PREVOST

SAFETY RECALL

SR13-53

DATE : AUGUST 2013	SECTION : 06-ELECTRICAL
SUBJECT :	TAIL LAMP PHOTOMETRICS

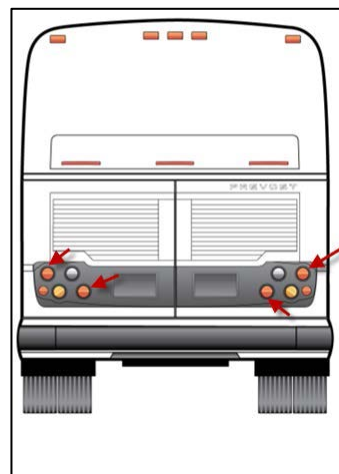
On vehicles affected by this recall, the photometric intensity of the tail lamps exceeds the requirements outlined in Federal Motor Vehicle Safety Standard (FMVSS) No 108 'Lamps, reflective devices, and associated equipment'.

The tail lamp may appear to be brighter at certain points confusing following drivers about whether the vehicle is braking, increasing the risk of a crash.

Performing a multiplex software update in a Prevost Service Center will correct light intensity.
